WM. H. ZIMMER POWER STATIONINSTRUCTIONS FOR UPDATING YOUR FSAR

Changes to the FSAR are identified by a vertical line in the right margin of the page. To update your copy of the ZPS-1 FSAR, remove and destroy the following pages and figures and insert pages and figures as indicated.

REVISION 93
MARCH 1983

FIGURE 7.3-1

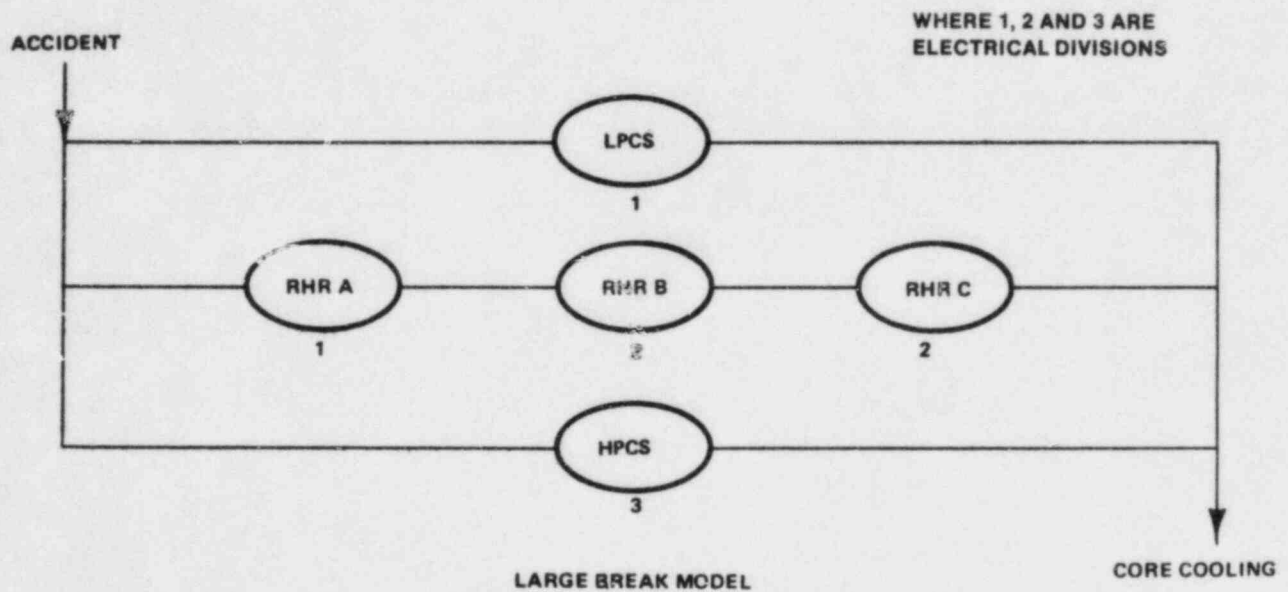
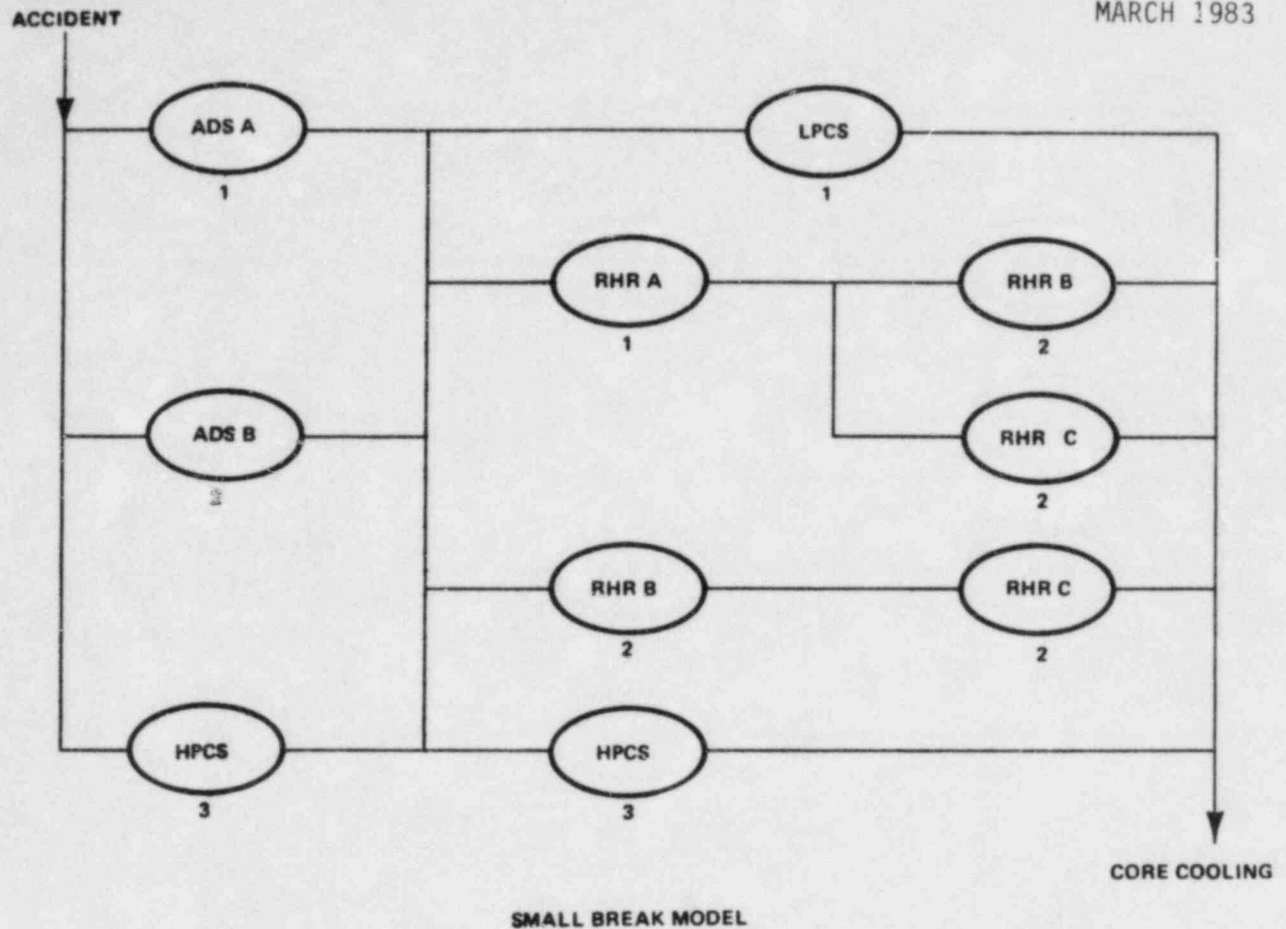
Regulatory Guide 1.47 (Revision 0)

Each motor-operated valve, blower, and recombiner heater in each of the redundant control systems annunciates an alarm in the respective control room panel for an inoperable condition such as loss of power or over-load trip. Control room indicating lights provide information on the status of valve position (open or closed), blower operation, or heater operation. System flow status is indicated on the respective control room panel for each control system and is annunciated for a low flow condition. Cooling water loss or low flow to the condenser is annunciated in the respective control room panel.

Regulatory Guide 1.53 (Revision 0)

Each control and instrumentation system is separate and therefore redundant. No single failure in one control system will interfere or prevent operation of the redundant control system.
